CHARLOTTE HISTORIC DISTRICT COMMISSION
CERTIFICATE OF APPROPRIATENESS-AMENDED

CERTIFICATE NUMBER: HDCADMRM-2019-00245

ADDRESS OF PROPERTY: 820 E. Worthington Ave

DETAILS OF APPROVED PROJECT: Rear Addition. The project is a right side rear addition that is no taller or wider than the existing building. The addition will measure 9' - ½" x 10' - 3" with a step down in the foundation for differentiation. The existing hipped roof will be extended over the new addition, with no increase in height and at the same roof pitch. Asphalt roof shingles will be installed to match the existing. Materials on the addition will be wood shingle siding, wood trim and wood rafter tails, all to match the existing materials on the house. A brick foundation will be used for the new addition but is to remain unpainted. The brick used for the new foundation should match the original brick used on the main house foundation prior to its (the original brick foundation) being painted.

SITE PLANS

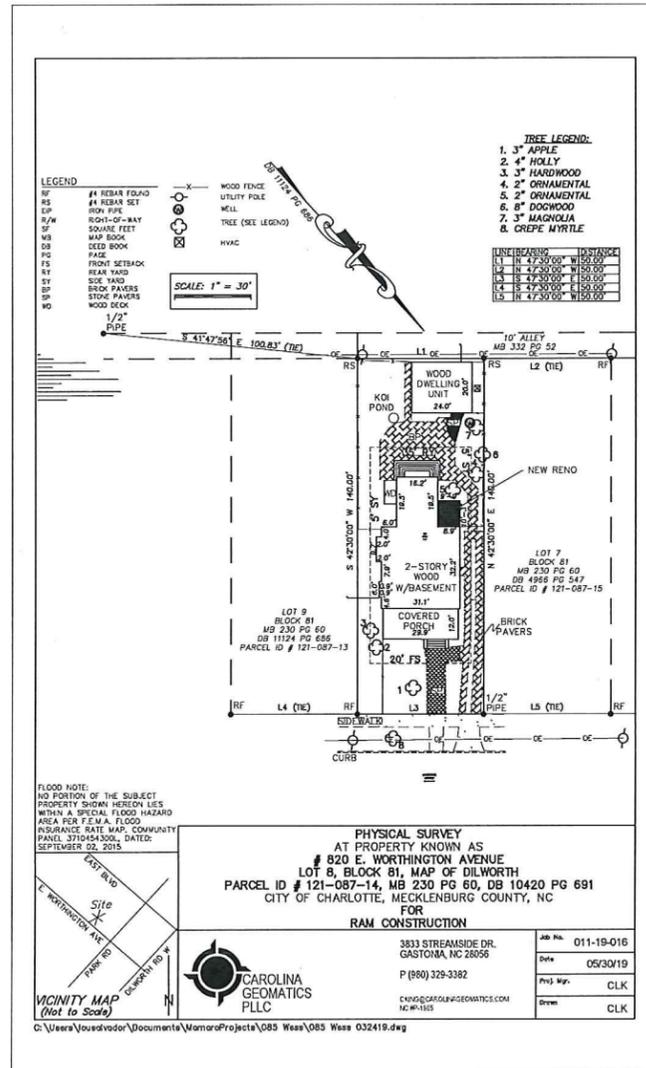
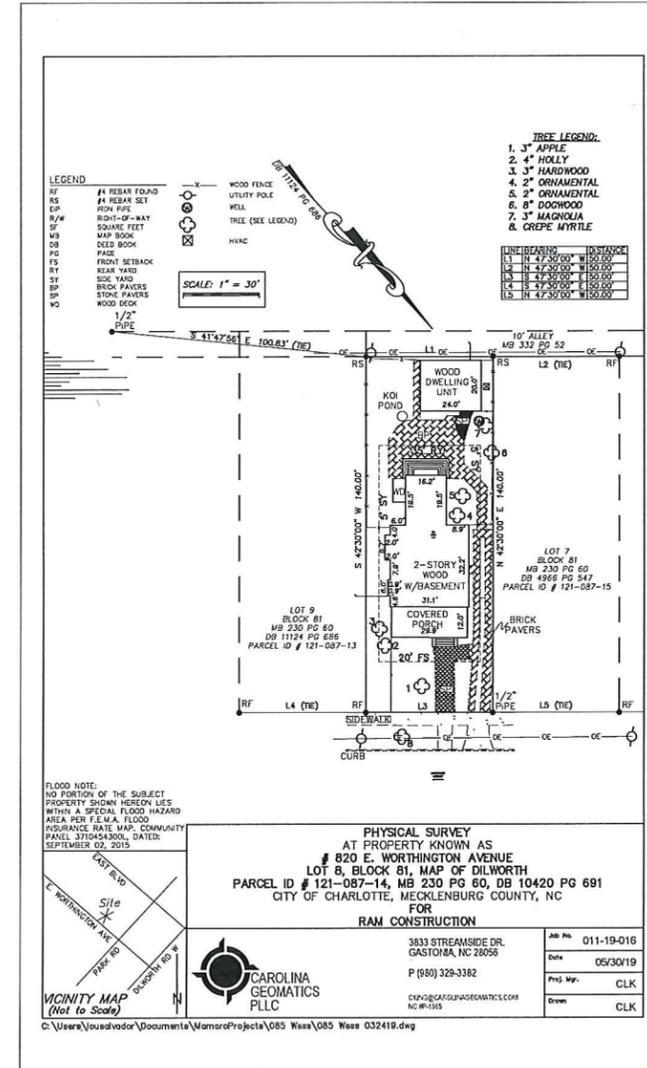
Without identifiers on the pictures, I am having a difficult time verifying where any of them are located and at that size, it's difficult to tell details. Elevations of those affected would be helpful. I need a site plan that indicates property lines and existing structures on the site in relation to them, this is also helpful for the rear yard open space calculations. The tree question was simply a verification, so the email stating that no trees are to be removed as part of this project is fine. I didn't see any specific details on materials in Acela other than brick and wood, it would be better for that to be spelled out in the plans. For example, if it's to match existing in color, size, materials, etc. please indicate that on the plans. Right now, the plans don't seem to reference materials in regards to the shake, etc. I need clarity on the material since there are options available out there that not wood. It looks like there are new and relocated windows, so I need specs on the new; Ply-Gem is not approvable by the HDC.

Lot size 50' x 145' = 7250 sq/ft
 Original rear yard 3557 sq/ft
 Existing Garage 480 sq/ft
 Old existing rear addition 315 sq/ft
 Original House 1401 sq/ft
 New proposed addition 95 sq/ft
 Existing (house and garage) impervious 2197 sq/ft
 All paving is permeable.

TOTAL - ORIGINAL HOUSE 1401 SQ/FT IMPERVIOUS
 TOTAL - ADDITIONS (INCLUDING PROPOSED AND EXISTING) IMPERVIOUS AT REAR YARD 890 SQ/FT
 TOTAL - ORIGINAL REAR YARD 3557 SQ/FT - ALLOWABLE USE @ 50% = 1778.5 SQ/FT
 TOTAL - LOT 7250 SQ/FT - ALLOWABLE IMPERVIOUS @ 35% = 2537 SQ/FT
 TOTAL IMPERVIOUS ALL STRUCTURES INCLUDING PROPOSED ADDITION 2291 SQ/FT = 31.6%

Addition right elevation - Nov. 2019

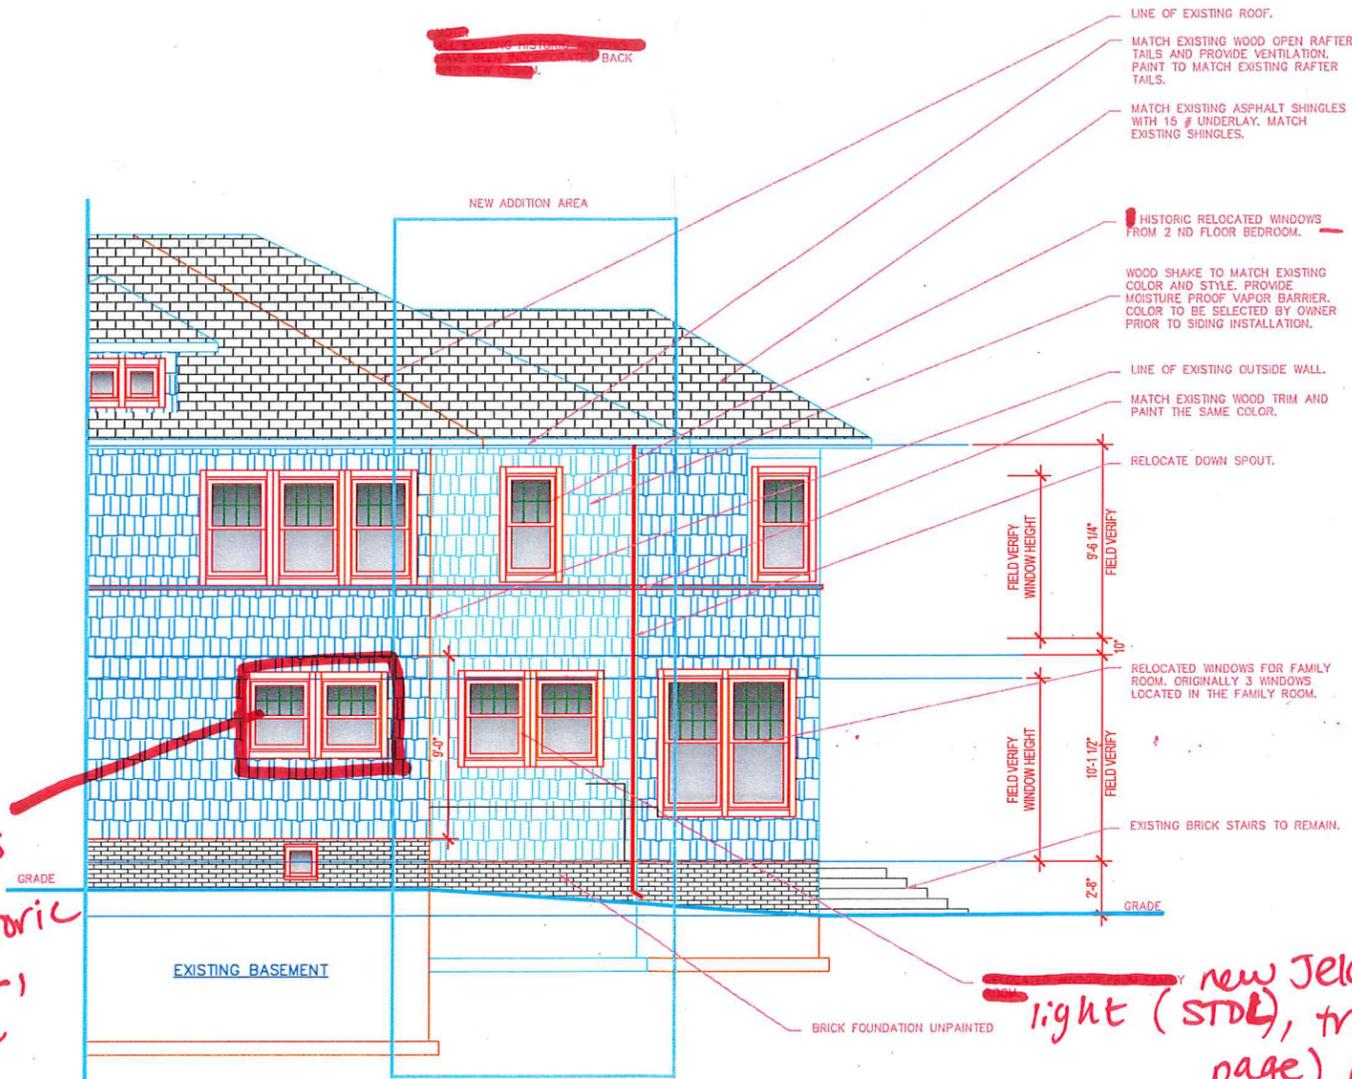
11/5/2019 Amendment: 1 existing window will be reused on the addition on the upper right-side elevation. New paired windows will be installed on the lower right-side elevation and the lower rear elevation of the addition. The existing non-historic paired kitchen windows on the lower right-side elevation in front of the addition will also be replaced. The new windows will be wood, double-hung, Simulated True Divided Lights (STDL) in an 8/1 pattern to match existing. No removable muntins will be used on the project. This approval does not imply approval of any wood window with visible plastic or vinyl components, as these do not meet HDC requirements. Window glass is to be the most translucent version available that meets NC building code requirements. All window trim and mullions will be wood and match the existing profiles on the house.

Jeld-wen
siteline windows
to replace
existing non-historic
windows, STD, trim to match
existing (see
window detail page)
center mullion
to match
existing

new Jeld-wen siteline windows, simulated true divided
light (STD), trim to match existing (see window detail
page), center mullion to match existing
